**COUNTY OF WESTCHESTER
NEW YORK**

ADDENDUM NO. 3

CONTRACT NO. 20-502

**LOW RISE BUILDING RENOVATIONS AND
HVAC IMPROVEMENTS - PHASE II
110 DR. MARTIN LUTHER KING, JR. BOULEVARD
WHITE PLAINS, NEW YORK**

| SIGN SCHEDULE & DETAILS | | Issue Date | |

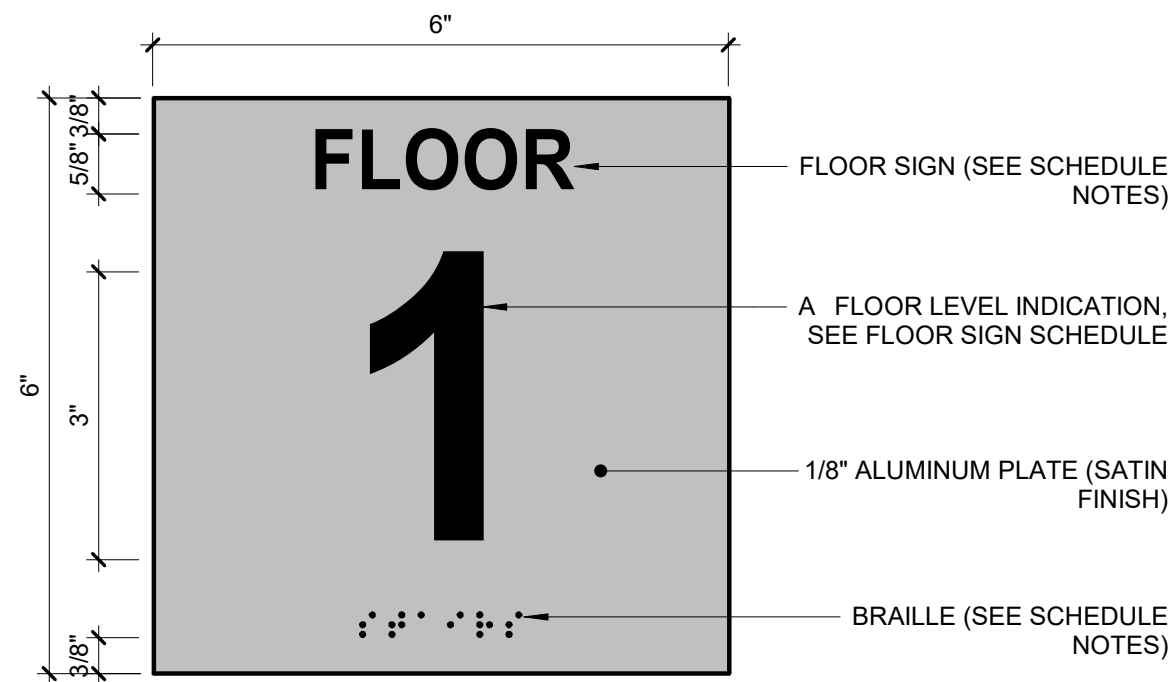
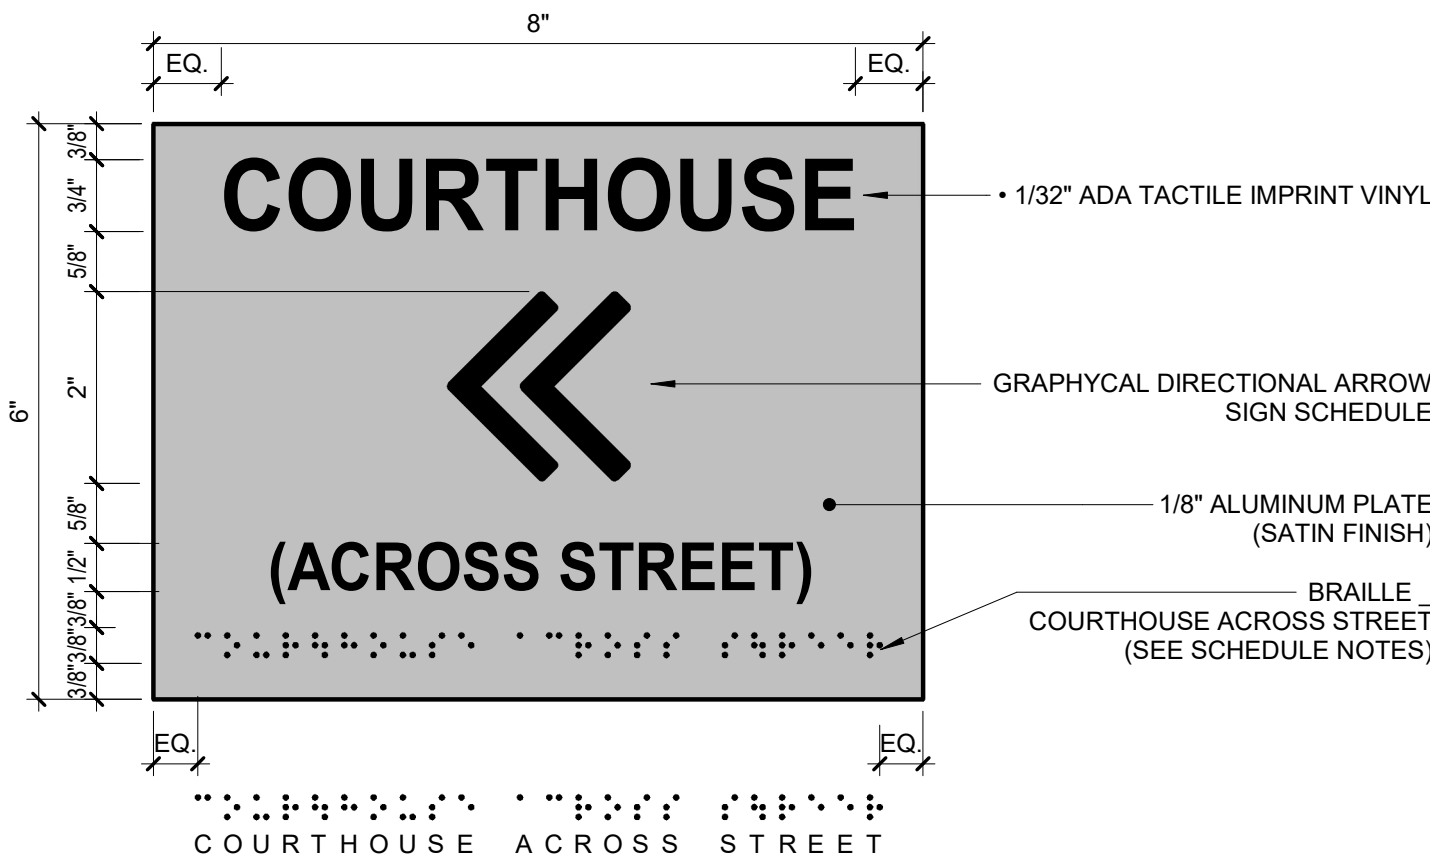
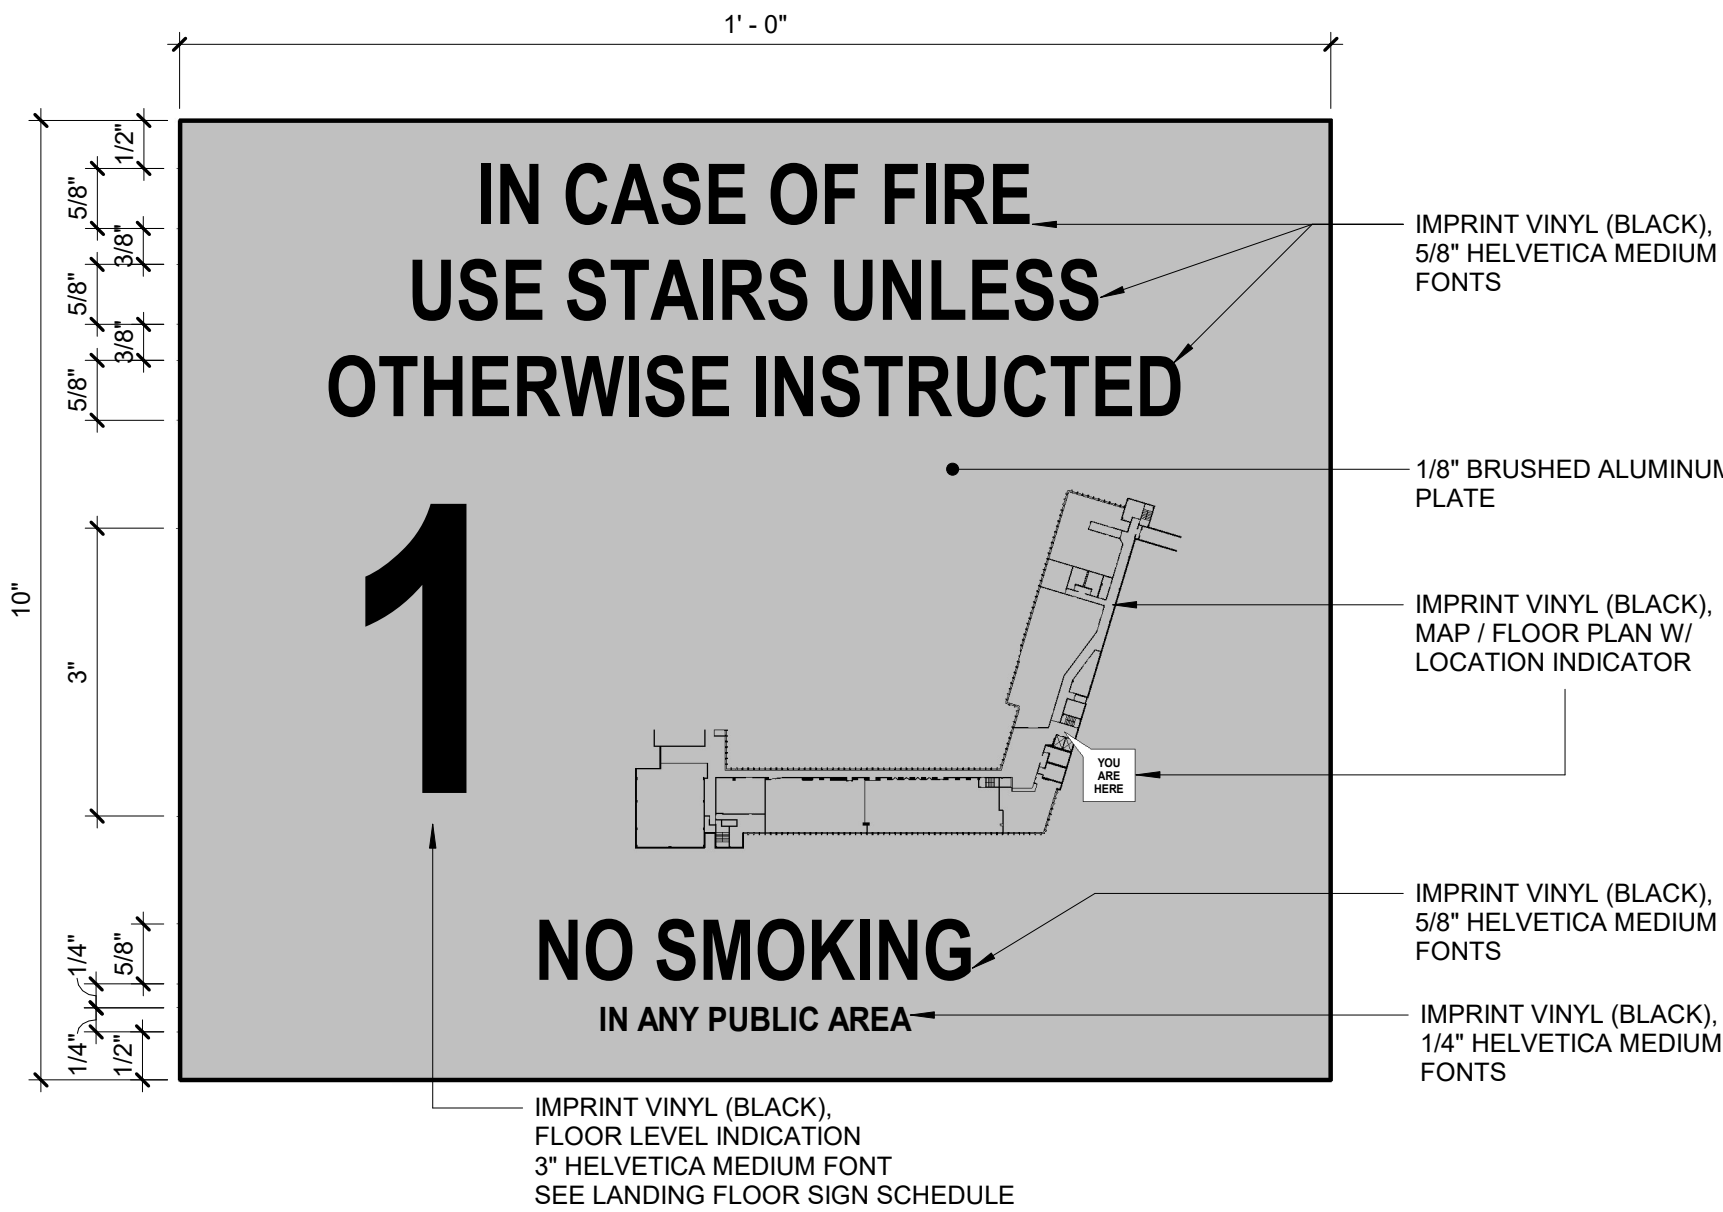
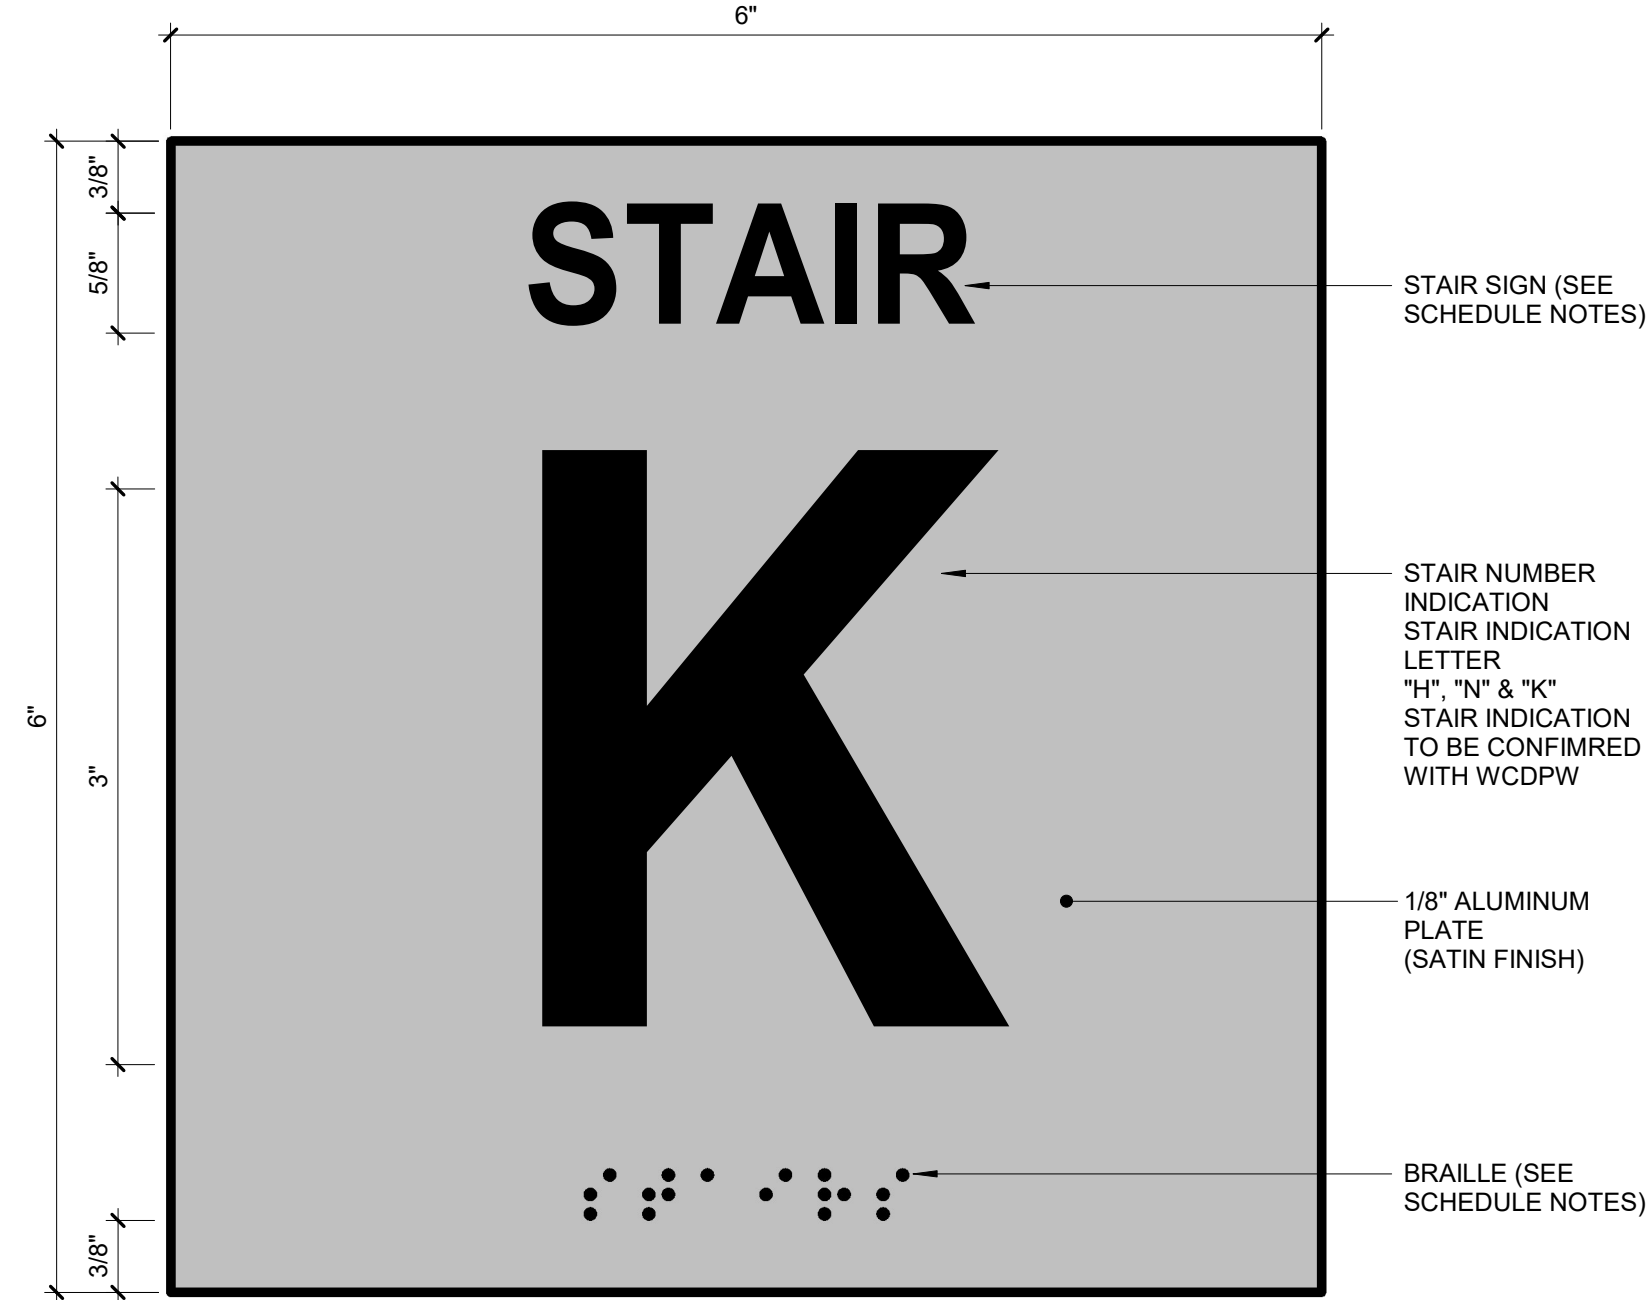
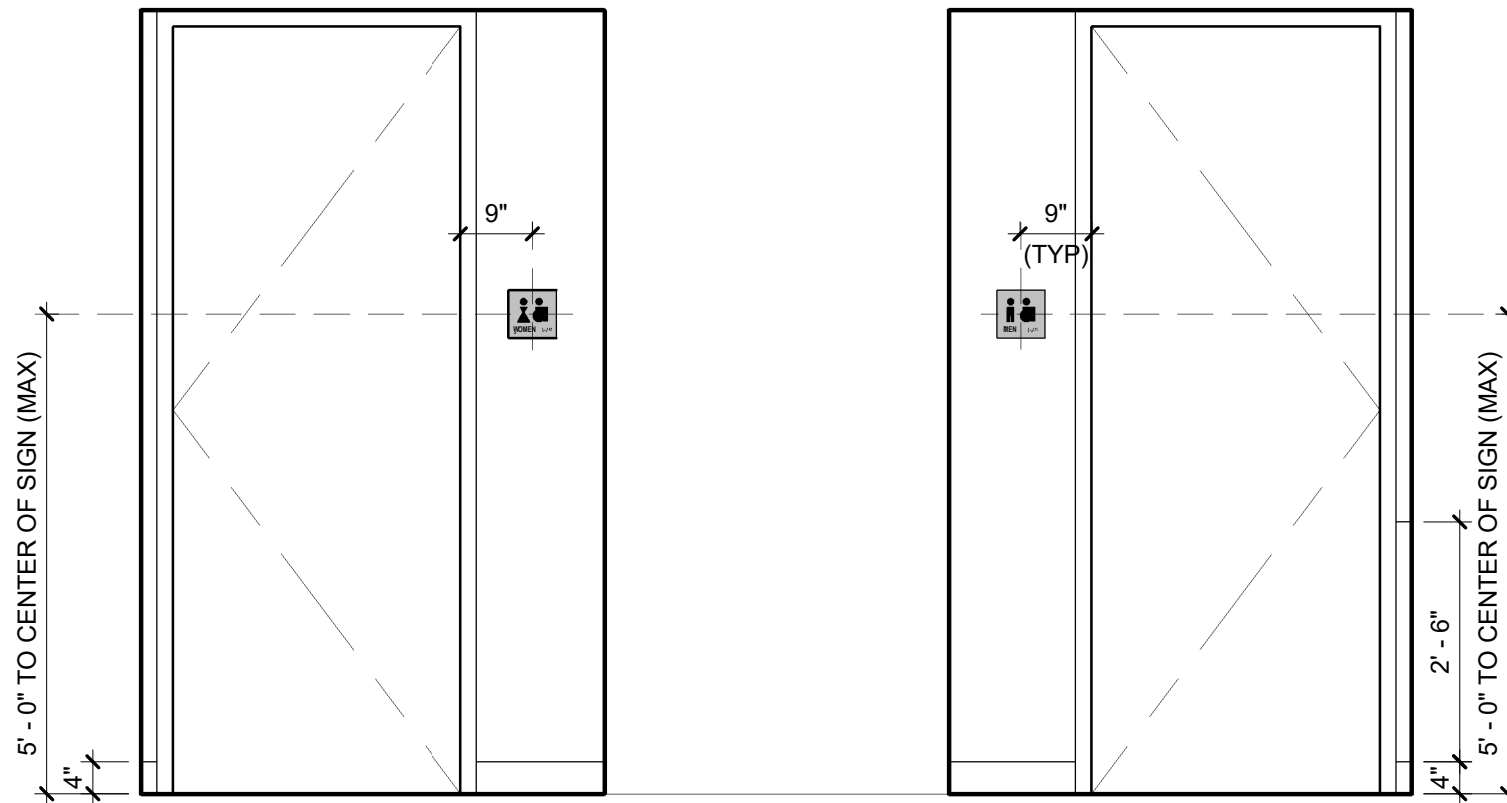
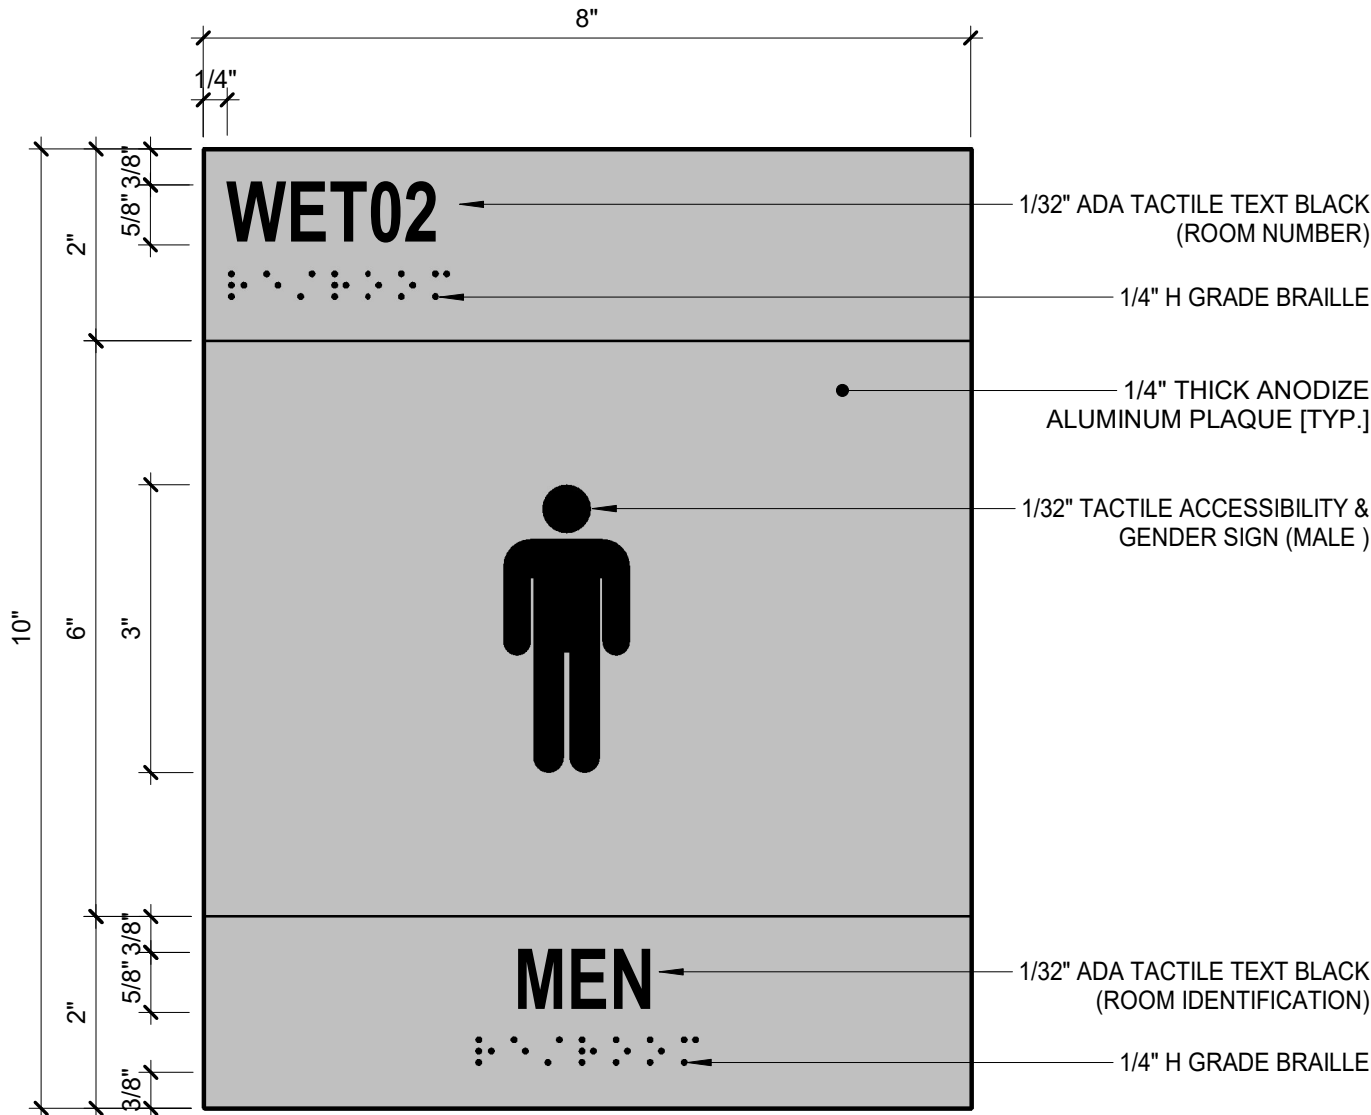
| Q16 | How many signs of each type are we to include Ref. DWG. A-303, signage schedule Please provide a signage schedule. | <p>Refer to drawings issued as part of Addendum #3 Please find revised finish plans, A-111 through 114 and signage details on A-303. Signage symbol S-# has been added on finish plans. Signage type, details, note, etc. have been modified on A-303.</p> |
